**RE: APPROVAL WITH MODIFICATIONS
INVESTIGATION WORK PLAN FOR MATERIAL DISPOSAL AREA C, SOLID
WASTE MANAGEMENT UNIT 50-009, AT TECHNICAL AREA 50, REVISION 1
LOS ALAMOS NATIONAL LABORATORY, EPA ID #NM0890010515
HWB-LANL-03-005**

The New Mexico Environment Department (NMED) has reviewed the *Investigation Work Plan for Material Disposal Area C, Solid Waste Management Unit 50-009, at Technical Area 50, Revision 1* referenced by LA-UR-03-8201, ER2003-0696 and dated November 2003 and updated in January 2004. NMED hereby approves the work plan with the modifications described in this letter. This approval with modifications letter supersedes the previous approval letter dated March 22, 2005. Modifications to the work plan and Historical Investigation Report (HIR) must be submitted as revisions to the work plan with redline strikeout of all edits. If the Permittees fail to implement the modifications, NMED will automatically rescind this approval.

Figure 3. Locations of pits and shafts at MDA C

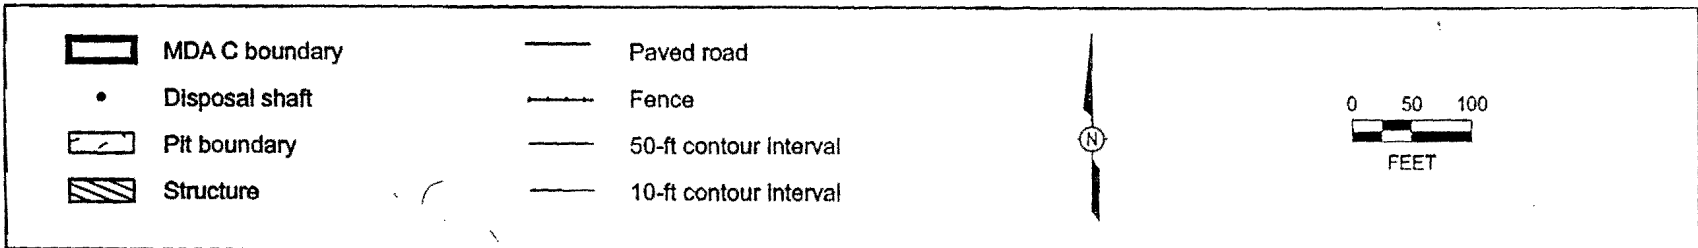
A) Borehole Locations: 32 boreholes total: 4 horizontal borings advanced beneath Pits 1-4 either beneath the long axes of the pits or at 150 ft intervals perpendicular to the long axes of the pits; the horizontal borings must be drilled at depths of approximately 30 feet bgs, this will correspond to ~ 5 ft below the estimated depth of the Pits; 28 vertical borings to 25 ft below the deepest detected contamination in accordance with Section IV.C.3.c.iii of the Order; one boring advanced to approximately 800 feet bgs to evaluate for the presence of vapor-phase

contamination and intermediate perched groundwater. (See attached map for vertical borehole locations)

The boreholes must be drilled within 10 ft of the nearest known location/feature and as close to the proposed location as possible. If access to a location is impossible because of the presence of utilities or structures, or other obstacles, arrangements must be made to drill as close as possible to the proposed location. See attached map for vertical boring locations (based on Figure 3 of the work plan).

The size of the site alone warrants more than 14 boreholes to characterize contamination and define extent. The combined width of Pits 1-4 is approximately 200-ft. The length of these pits is approximately 550 ft-600 ft. Pit 5 is approximately 600 ft long and 100 ft wide. Pit 6 is approximately 550 ft long and 100 ft wide. As a reminder, Section IV.C.3.c.iii of the Order requires that boreholes be advanced directly adjacent to the down-slope end of each pit, at the lowest base elevation point of each disposal pit, at the corners of each disposal pit, at 100-ft intervals along the sides of disposal pits 1-6, at 70-ft intervals along the sides of the chemical pit, at the ends of each shaft row, at 50-ft intervals along each shaft row, and adjacent to the locations of the strontium-90 disposal shaft. NMED estimates that this could be as many as 50 boreholes. However, data provided by the Permittees suggests that 33 borings in the locations shown on the attached map may be adequate.
